AGENDA ELLETTSVILLE PLAN COMMISSION Zoom Meeting Thursday, March 4, 2021 - 6:00 P.M.

PC 21-06 – Preliminary Plat Staff Report

PC 21-07- Preliminary/Final Plat Staff Report

PC 21-02 – Preliminary Plat Staff Report

Submitted by Kevin Tolloty, AICP Director, Ellettsville Planning December 21, 2020

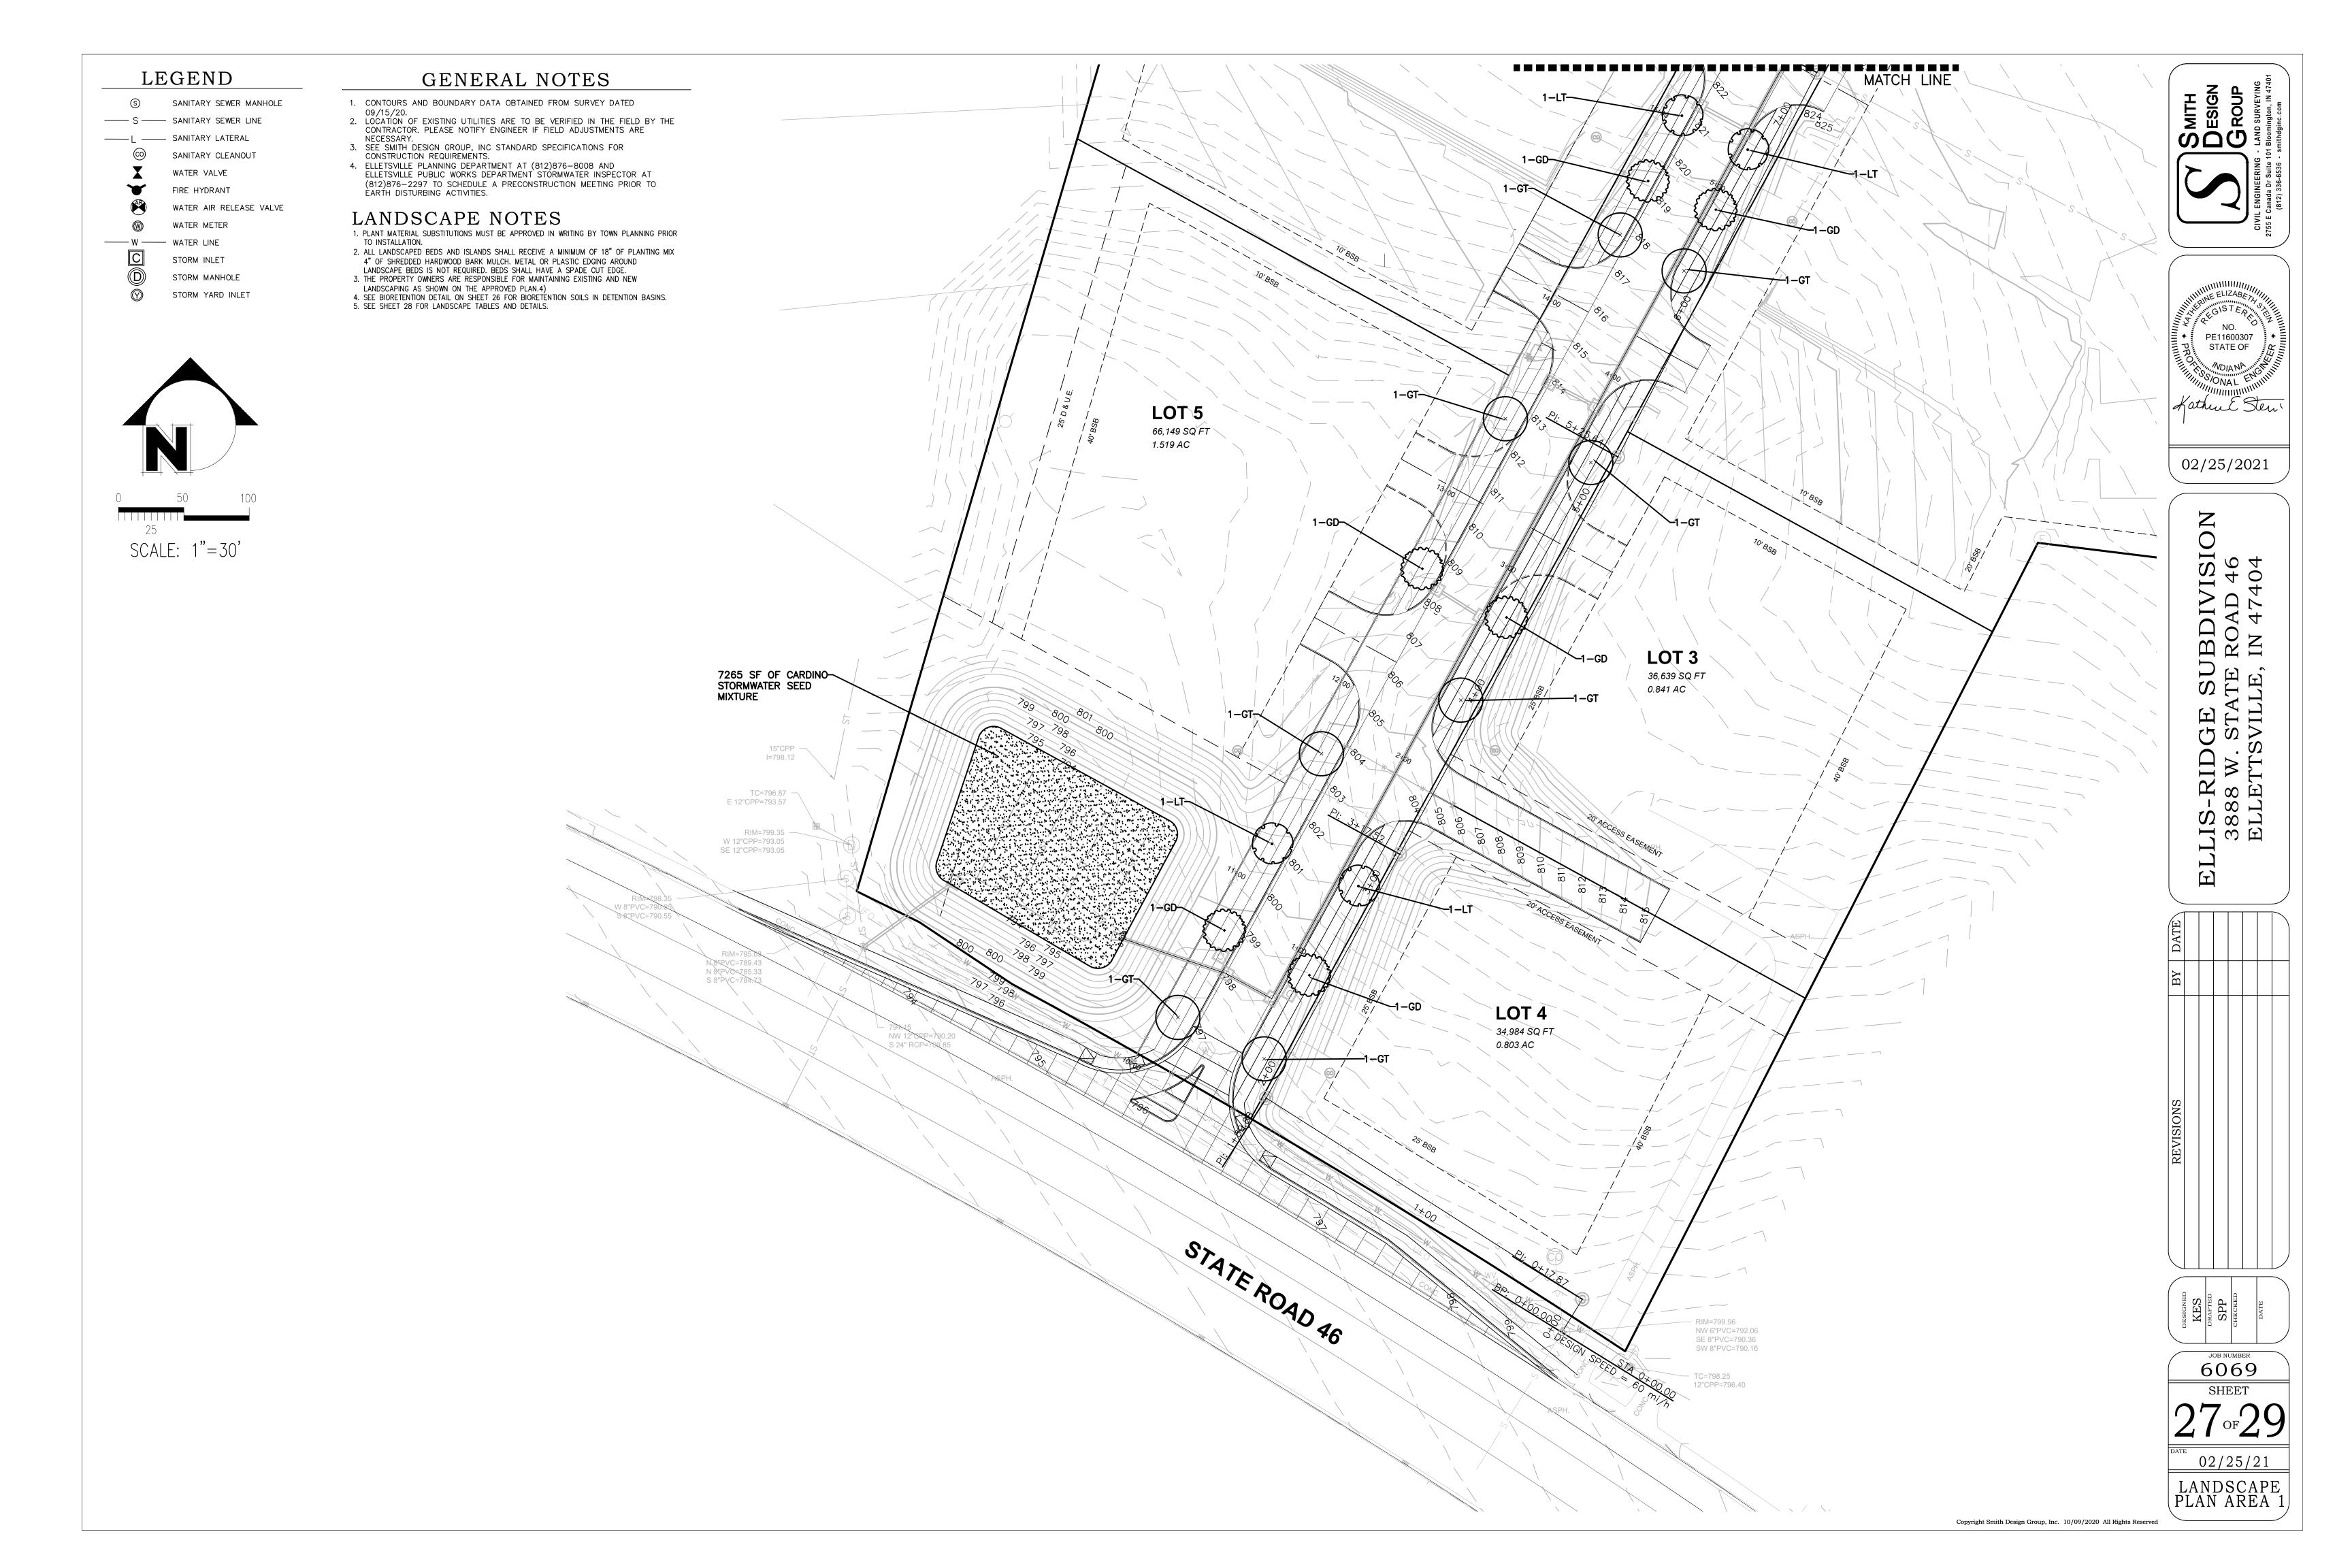
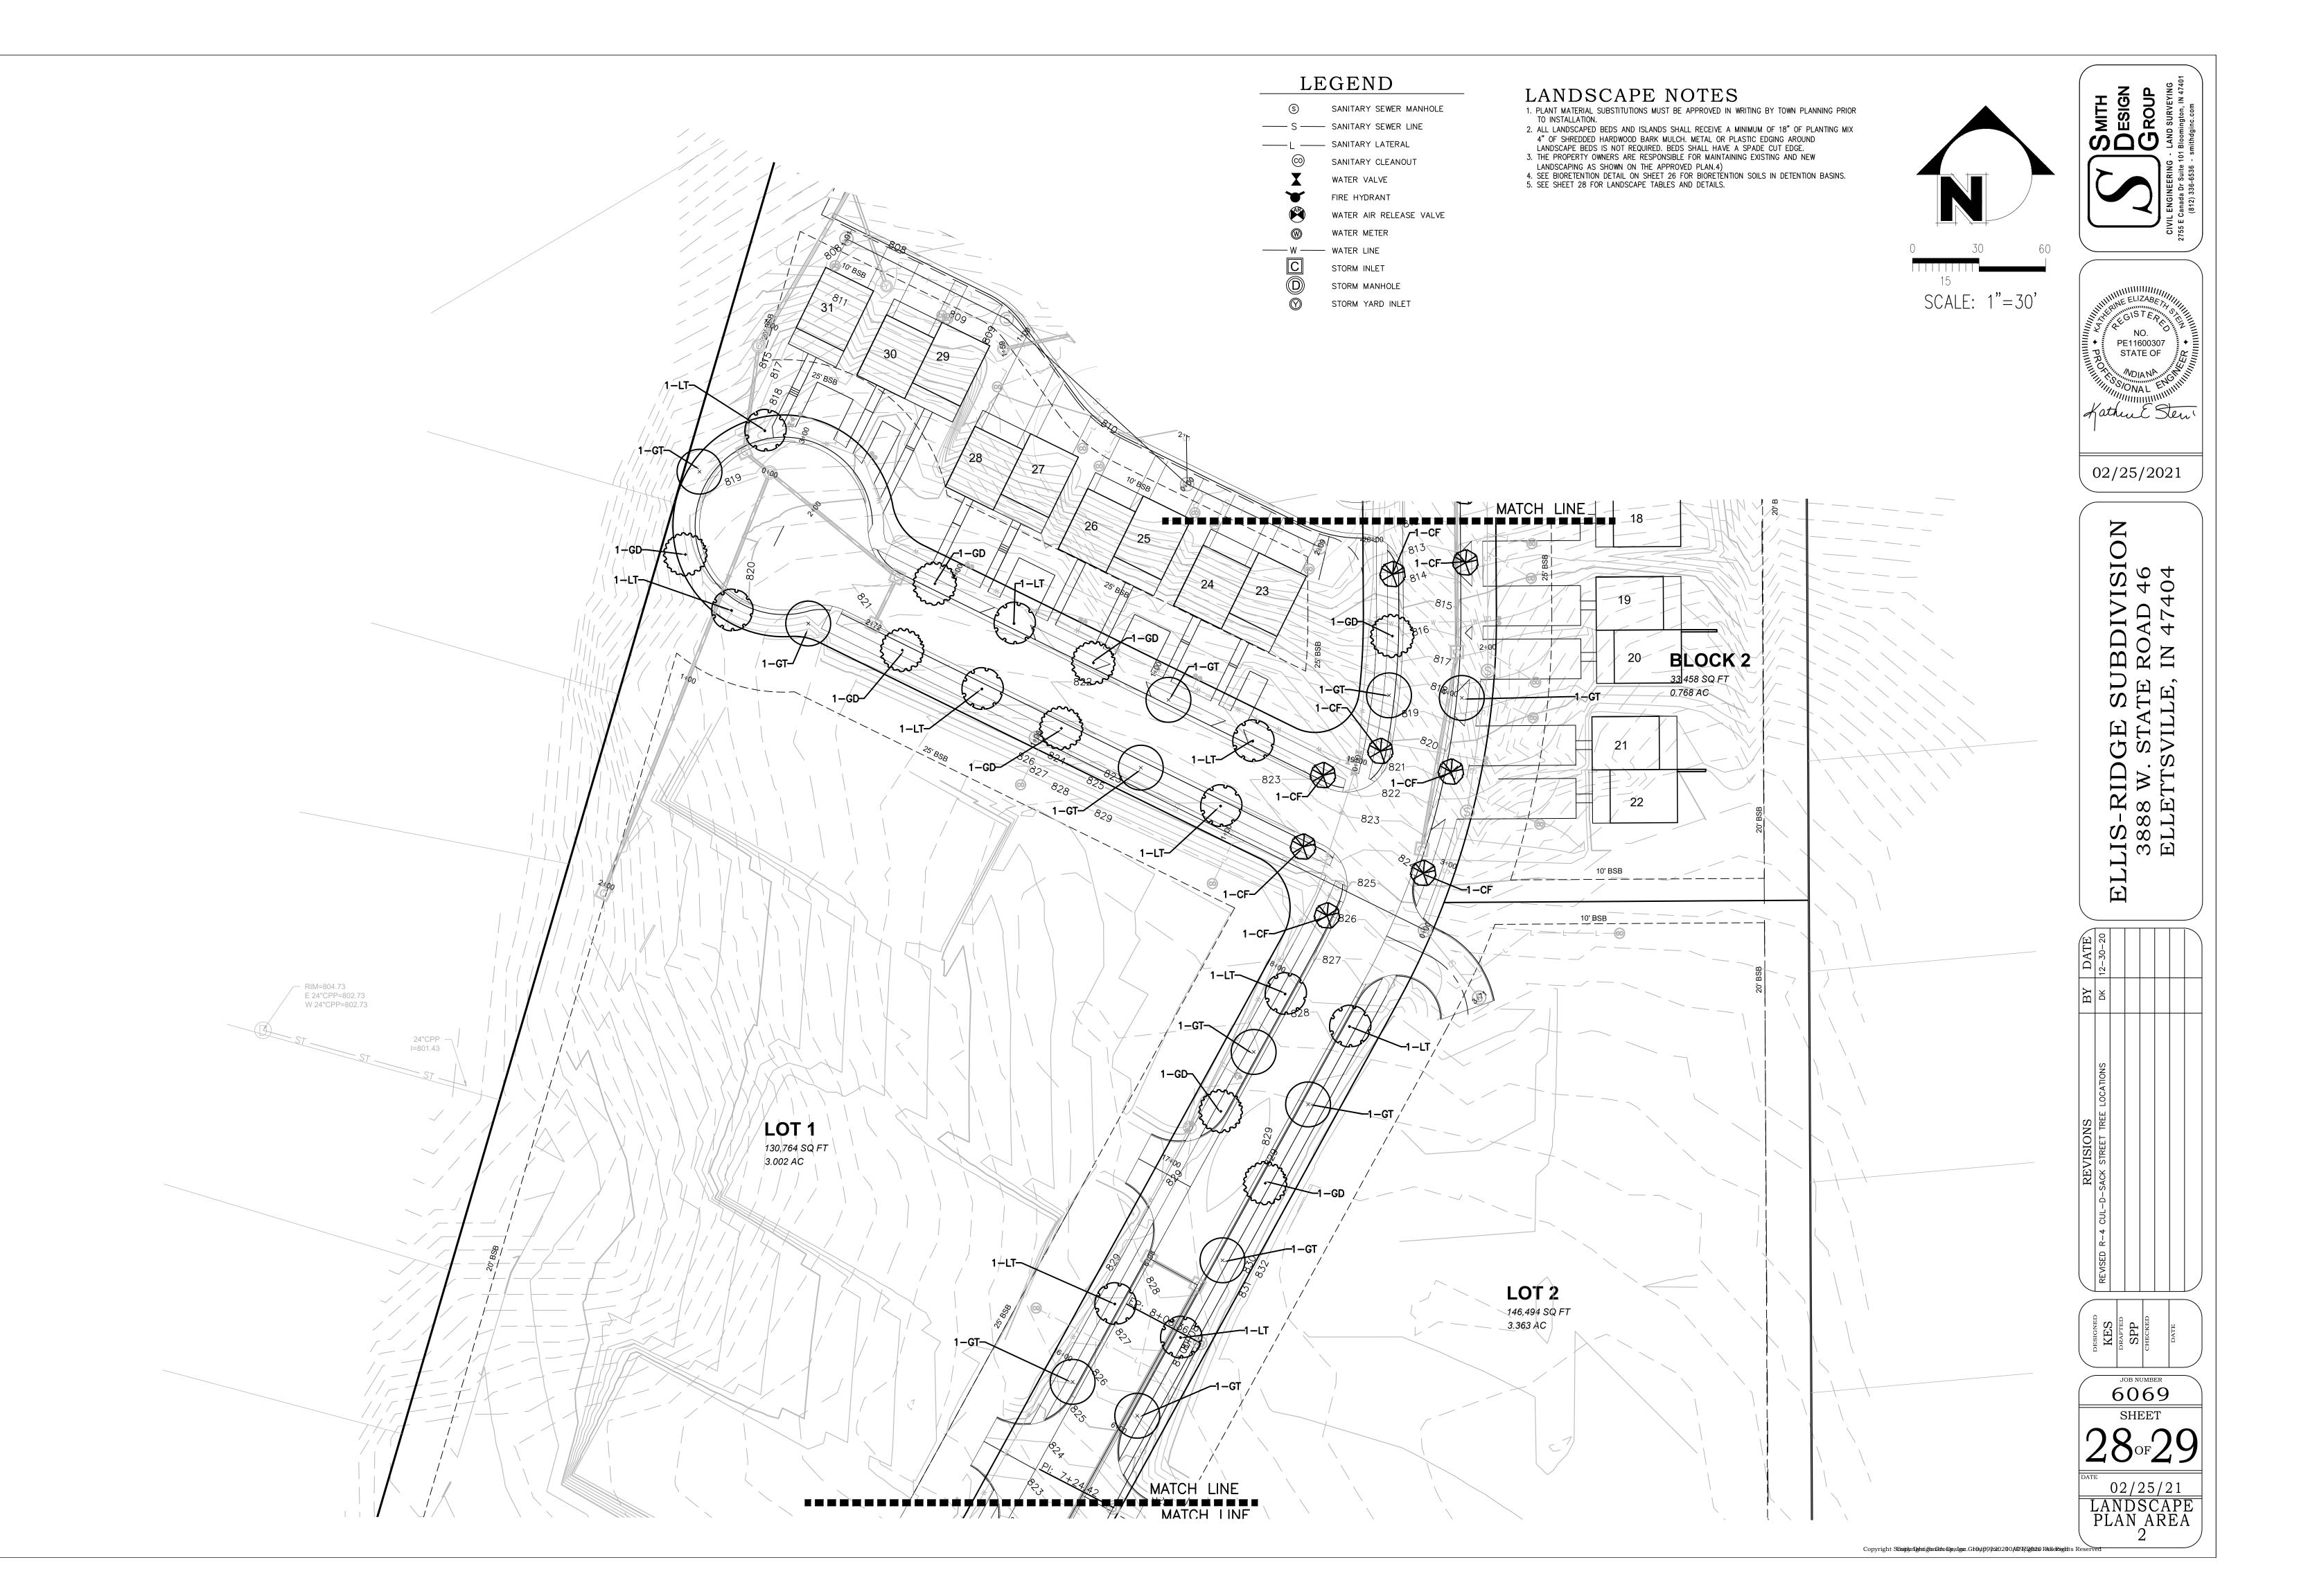
1. A landscape plan will need to reviewed prior to the Plan Commission meeting.

- 2. Street names will need to be provided for the cul-de-sac and the road connecting Ashbrook and SR 46.
 - a. Ellis Court cannot be used as there is already an Ellis Road in Monroe County.
- 3. All paired patio homes shall have a minimum of four (4) dedicated parking spaces.
 - a. This includes any spaces in a garage, driveway, or other dedicated off-street parking.
- 4. Alleys should remain as private roads.
- 5. Final plans shall be stamped by engineer.

- 1. Tracer wire should be used on all newly installed lines.
- 2. On page 24, the street sign detail shows in accordance with the City of Bloomington. Please change that to Town of Ellettsville (Town Ordinance 153.086)

- 1. Typical sections show the sidewalk dimension as 5 feet but there is a note referring to 4 feet.
- 2. An INDOT driveway permit will be required.
- 3. Setbacks should double when the commercial sections are adjacent to the residential zoning. The rear yard setback would be increased to 40 feet instead of the 25 feet as shown. (152.190)

- 4. The GIS aerial photography shows a pond on the property. The existing contours and development plan do not indicate a pond on the property. Removal of the pond should be approved by the appropriate governmental agencies.

- 7. Please provide detail of the retaining walls.
- 8. The detention pond underdrains should be shown on the grading and drainage plans.
- 9. The sanitary sewer will be reviewed by the Eastern Richland Sewer Corporation.

- 10. Drainage calculations will need to be submitted. The detention pond in the southwest corner of the property is shown connecting to and existing structure from the Springs Valley subdivision. The existing structure has a 12-inch pipe and Str. 101 has an 18-inch outlet pipe connecting to that structure. In addition, the depth of the existing structure does not seem to be adequate to connect to Str. 101.
